1984 Corvette: Service Bulletin: Side Door Lateral Movement

Bulletin No: 84-118, Section: 10 (I)

Date: April, 1984

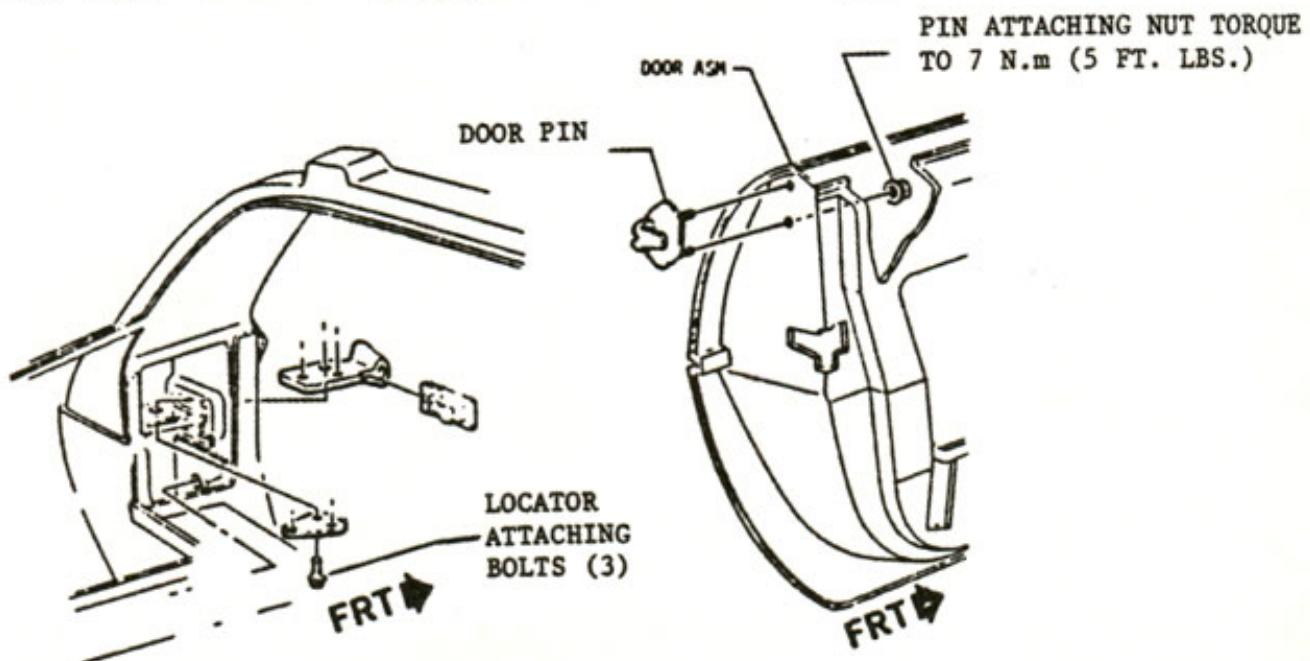
Verify the plastic sleeve is installed in the pin locator assembly. With the vehicle door closed, loosen the locator three (3) attaching bolts (see Figure 1). The locator assembly is to be centered fore-aft and vertically on the door pin. Push the locator outboard to fully engage the door pin and tighten the locator attaching bolts to 11 N.m (8 ft. lbs.)

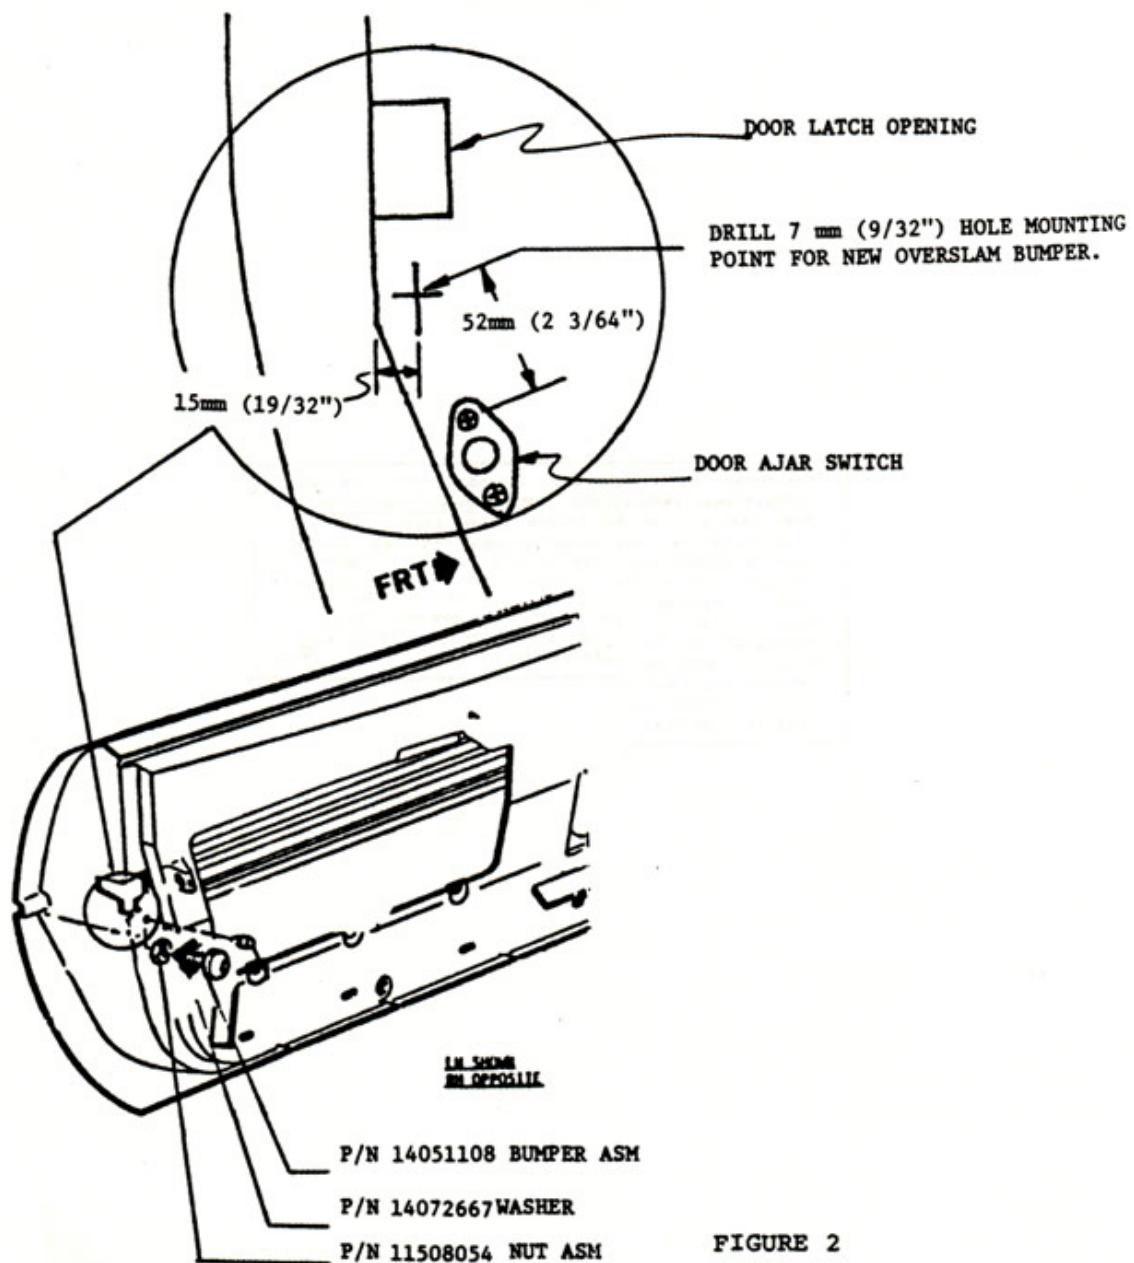
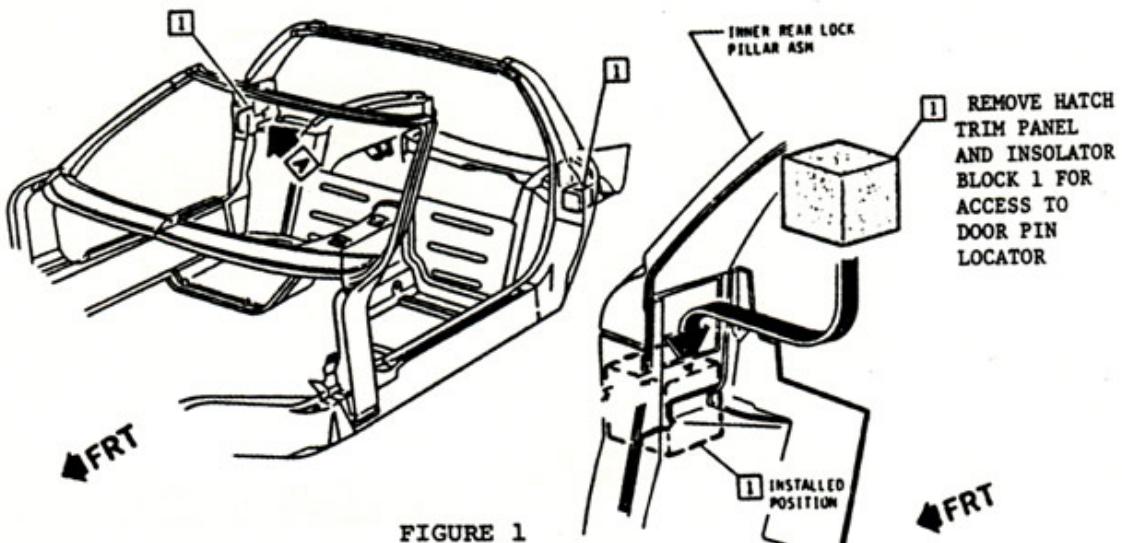
Some early built vehicles did not have overslam bumpers. If this is the case, it will be necessary to drill a 7mm (9/32") hole in the door (see Figure 2).

Replace the discarded production bumper(s) with bumper, P/N 14051108, attaching nut, P/N 11508276, and P/N 14072667, flat washers, which are to be used as bumper shims. The number of shims required will vary form vehicle to vehicle depending on "Build stacks".

Add shims (washers) between bumper and door, as required, to eliminate lateral door movement (see Figure 2). DO NOT "OVERSHIM" BUMPER.

Once shim pack has been established, tighten bumper retaining nut to 12 N.m (9 ft. lbs.) and check the door ajar lamp for proper operation. The door ajar switch is self-adjusting and cannot be reset.
